Flight Procedures Cover Page	Task Action: FLIGHT CHECK	Task Type: IAP	Estimated Chart Date: 12/24/2026	APWS Task ID: B96524360A164F0B84E0F76518FAF6FB	APWS Project ID: 230653690E4E48408A2093466E379B59
Procedure: RNAV (RNP) Z RWY 16R AMDT 3		Enroute: NO	Specialist: Stubblefield, Byron		Agreement Number:
Airport ID: KDEN			Airport City: DENVER		State: CO
Facility ID:	Facility Type:	Flight Inspection Remark Type: New FC Slot			
Procedure Comments: ACTIVE DATA USED FOR KDEN AIRPORT AND RWYS. WAIVER (1): FAA Order 8260.58D, table 1-2-2 Indicated Airspeed (KIAS), Minimum Airspeed Restriction, maximum speed of 170kts at ZITNO is required to alleviate aircraft exceeding the speed limitation and overshooting the course. WAIVER (2): FAA Order 8260.58D, paragraph 1-3-1E(2), The flight path of the leg from HELBY to OBIBY does not remain within 15 NM of the ARP coordinates. WAIVER (3): FAA ORDER 8260.58D paragraph 1-3-1c, RNAV (RNP) Z RWY 16R using the leg length from KAILE to OGINE of 1.90 NM. APPROVAL LETTER (1): FAA Order 8260.19K, paragraph 8-6-11N(1), Mandatory altitudes at CLFFF, GSHEN and FESKA. POC: CASEY HILL 405-954-0624 QUALITY 9 CHECKED BEGUE QUALITY 37 CHECKED

DENVER, CO
KDEN
RNAV

RNAV (RNP) Z RWY 16R
DENVER INTL (DEN)

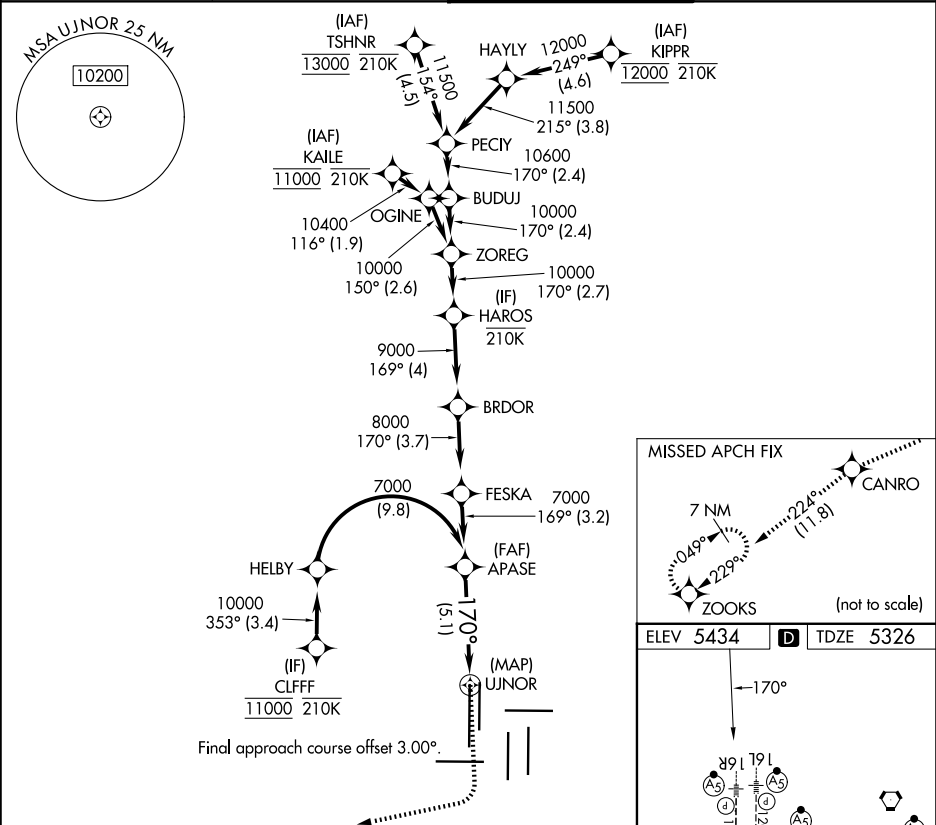
ISSUE: MANDATORY ALTITUDE RESTRICTION: INTERMEDIATE SEGMENT CLFFF-
HELBY-APASE

Per the 8260.19K 8-6-11n, maximum, mandatory or block altitudes in the intermediate, final and/or missed approach segment require Flight Standards approval.

The intermediate segment for the RNAV (RNP) Z RWY 16R CLFFF-JOEZZ-LEGIY-GSHEN-FESKA-APASE has a mandatory altitude of 11000 MSL at CLFFF. The following four STARS that service KDEN have a mandatory altitude of 11000 MSL at CLFFF: CLASH ARRIVAL, NIIXX ARRIVAL, TBARR ARRIVAL and SSKII ARRIVAL.

Per the 8260.3G 2-2-7f, an altitude restriction must be established at the termination fix of the STAR if the same fix is charted on an approach procedure. If the approach procedure fix has an altitude restriction associated with it, then the STAR termination altitude restriction must be identical to it.

This procedure has been flight checked and flown as satisfactory in both the current revision and previous amendments with the same mandatory altitude restriction with no issues noted by Flight Check, ATC operations or the flying public.

Requesting approval to continue to publish the mandatory altitude restriction at the intermediate fix CLFFF IAW the 8260.3G 2-2-7f criteria. It is not possible to easily convert CLFFF to an initial fix without significant redesign of the subsequent segment due to leg length and TF to RF requirements.
